# **Deepwater Horizon Technical Rig Audit January 2005**

## **Introduction**

At the request of George Coltrin, Drilling Operations Team Leader, NAX deepwater GoM a technical rig audit was undertaken of the Deepwater Horizon semi submersible drilling rig. The Deepwater Horizon will undertake deepwater exploration wells, the initial two NAX exploration wells, Stones and Kaskida, represent significant challenges. The Stones well will be drilled in 9600' of water, representing the deepest water depth the rig has worked in. The Kaskida well will be drilled through 15,000' of salt to a total depth of 33,000' MD, representing a record depth well.

#### **DP Log**

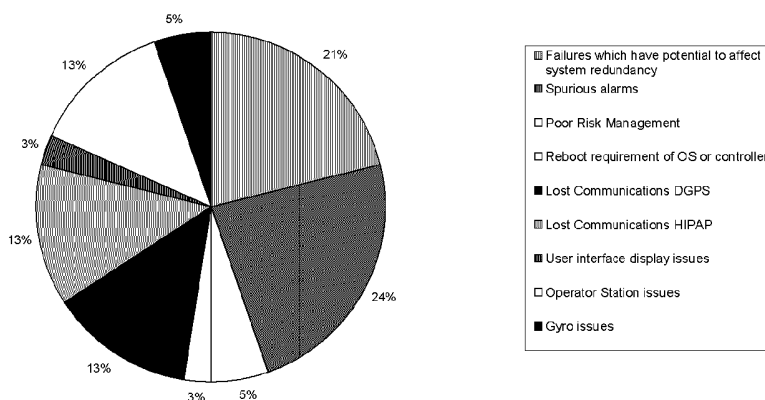
System status board is updated regularly and the 6 hourly status checks are considered adequate. There is a DP rough log book maintained along with a DP anomaly book. Having reviewed the anomaly book a number of observations can be made.

From the anomaly log, which has been well populated, a subjective analysis has been undertaken to identify any trends in the data being recorded. Two events occurred which gave some concern. The first being on February 8 2004, this related to routine maintenance on the uninterruptible power supply that supplied gyro #1. Gyro #1 was deselected to the back up DP system while position reference(s) system was selected. The DP Operating station crashed (OS 2) when the gyro was enabled to the system. This operating station is in the central control room. Control measures and risk assessment should be in place when conducting any maintenance on the DP system-supporting infrastructure. This incident indicates that the risk assessment carried out did not consider the implications of the work. It is not clear from the report whether an advisory level was initiated.

The second incident occurred on the 29 March 2004 whilst Thruster #8 was undergoing maintenance. The thruster had been run locally in simulation mode. On taking Thruster #8 out of simulation mode the DP system received an alarm stating 'RPM out of limits'. The DP system reacted to this as its logic indicated a thruster run away. Hence the four thrusters already on line ramped up to counter Thruster #8 which was not in fact running. Again the running of maintenance simulations whilst connected requires risk assessment to assess all risks to the DP system. The impact is noted as a 2.8m position loss.

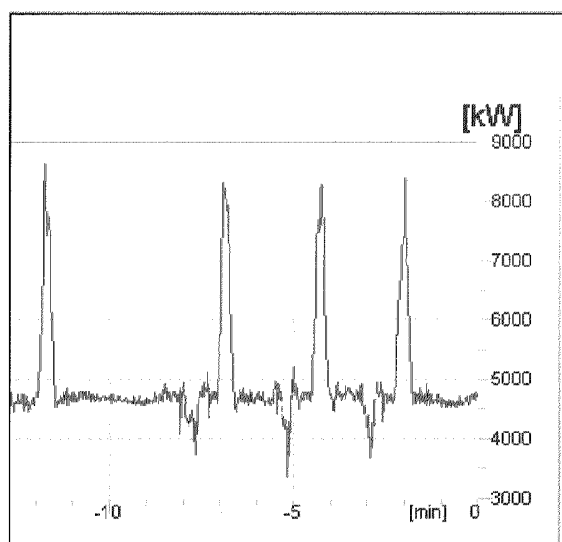
The software storage location was not centralised and hence no fireproof protection was afforded

On requesting APOS software it was noted that the latest upgrade disk could not be located

On checking DP Operator stations at the central control room, superseded software from 1999 was located. This indicates software controls such as quarantining of superseded software, is not in place.

The importance of software control on safety critical systems cannot be over emphasised and this issue requires urgent attention
